- Intermittently No Connection in Reverse (power Interruption)
- Transmission Slips When in Reverse

**Figure 1**

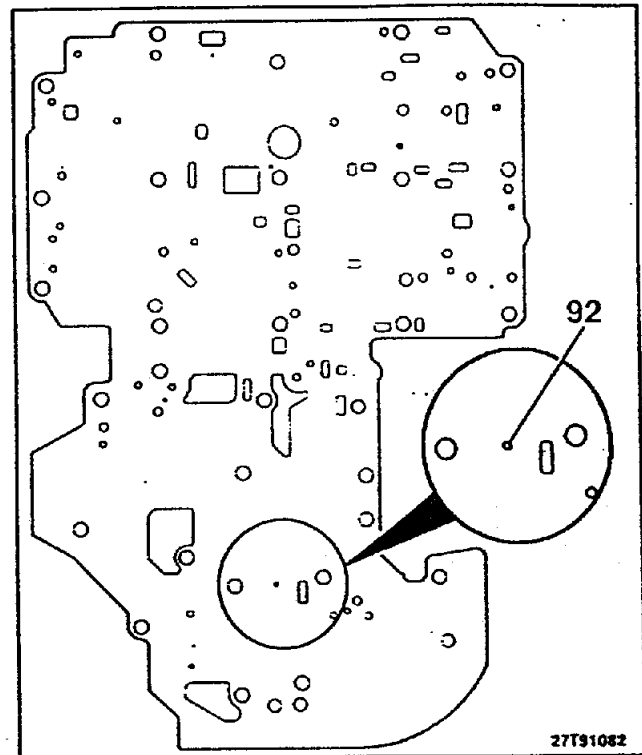
Extremely high Reverse engagement pressures leaking between Bore 92 of large intermediate plate and Drain valve KS (103) in transmission case due to:

1. Bore 92 is too large (4 mm diameter).
2. Graphite gasket material of original large intermediate plate gasket not sealing properly.
3. Steel cover plate (2, Figure 2) on upper side of large intermediate plate becoming loose or of uneven tightness.

1. Replace large intermediate plate, part no. 129 277 15 14. Ensure Bore 92 of replacement plate is 2 mm diameter (Figure 1).
Tightening torque: 8 Nm
2. Replace large intermediate plate gasket, part no. 129 277 09 80.
3. Replace or retorque steel cover plate (2, Figure 2), part no. 129 277 19 94. Tightening torque: 4 Nm.

Correct diameter of Bore 92 = 2.0 mm
